Subdivision Authority

File No. LDA11-0031

RE: Tentative plan of subdivision to create 102 single detached lots and two (2) Public Utility Lots from a portion of SE 36-52-26-4 and SW 36 52-26-4; located west of Secord Drive;
SECORD

SUBDIVISION CONDITIONS OF APPROVAL MAP

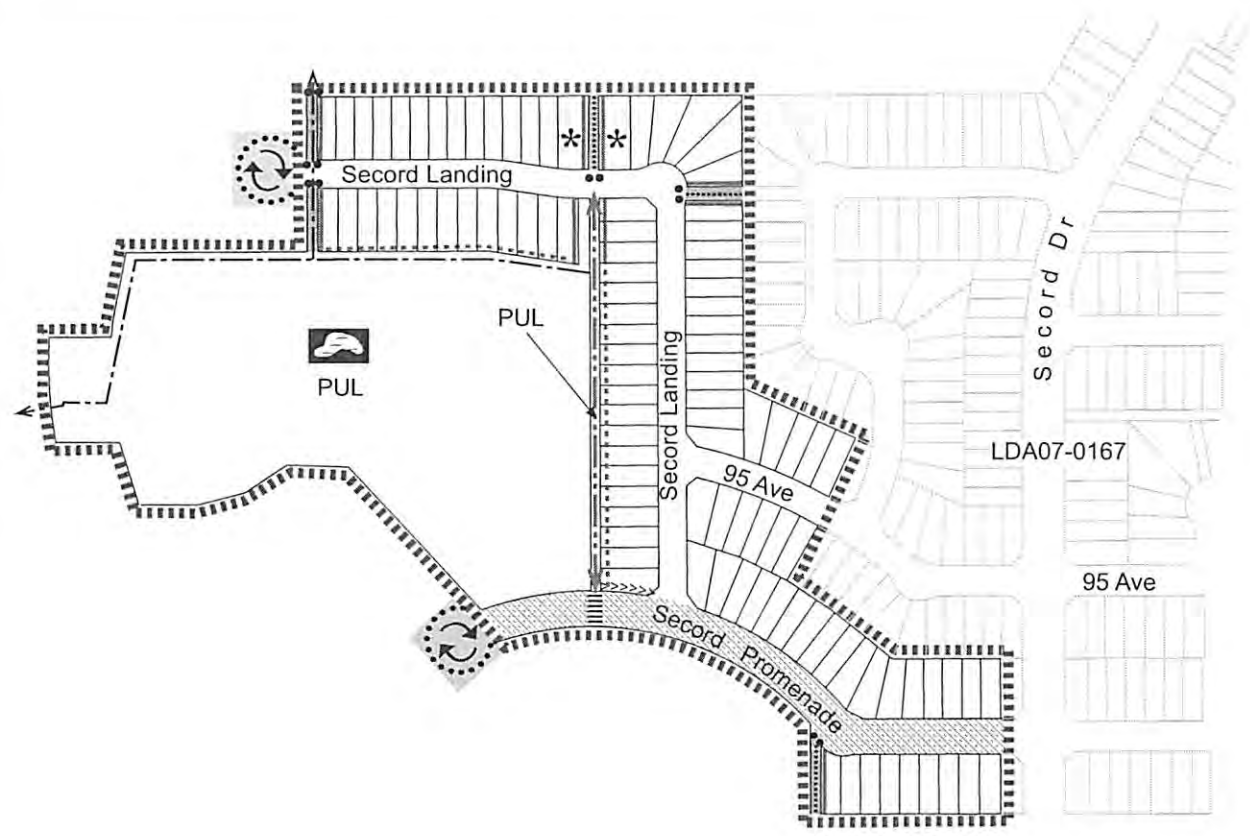
4. that the owner dedicate the walkways as road right-of-way, as shown on the "Conditions of Approval" map, Enclosure I;
5. that the owner prepare a 7.5m Pipeline Development Setback Restrictive Covenant in favour of the City of Edmonton, as shown on the "Conditions of Approval" map, Enclosure I; and

7. that the owner construct Secord Promenade with a minimum 11.5 m carriageway (20 m right-of-way) to the satisfaction of Transportation Services, as shown on the "Conditions of Approval" map, Enclosure I;

8. that the owner construct a 3.0 m hard-surface, shared use path, with a dividing yellow centreline, and shared use signage, lighting, bollards and landscaping, to the satisfaction of Transportation Services, as shown on the "Conditions of Approval" map, Enclosure I;

9. that the owner construct a 3.0 m hard-surface, shared-use path at a standard capable of handling emergency vehicle access within the pipeline right-of-way, to the satisfaction of Transportation Services, as shown on the "Conditions of Approval" map, Enclosure I;

10. that the owner construct 1.5 m concrete sidewalks with bollards and lighting to the satisfaction of Transportation Services, as shown on the "Conditions of Approval" map, Enclosure I;

11. that the owner provide zebra marked crosswalk with curb ramps and pedestrian signage to the satisfaction of Transportation Services, as shown on the "Conditions of Approval" map, Enclosure I;

12. that the engineering drawings include the construction of two (2) 12 m radius gravel surface temporary turnarounds with bollards or mini-barriers, required at CCC or as required by Transportation Services, as shown on the "Conditions of Approval" map, Enclosure I, to the satisfaction of the Transportation Services;

13. that the owner construct all fences wholly on privately owned lands to the satisfaction of Infrastructure Services and Sustainable Development, as shown on the "Conditions of Approval" map, Enclosure I; and
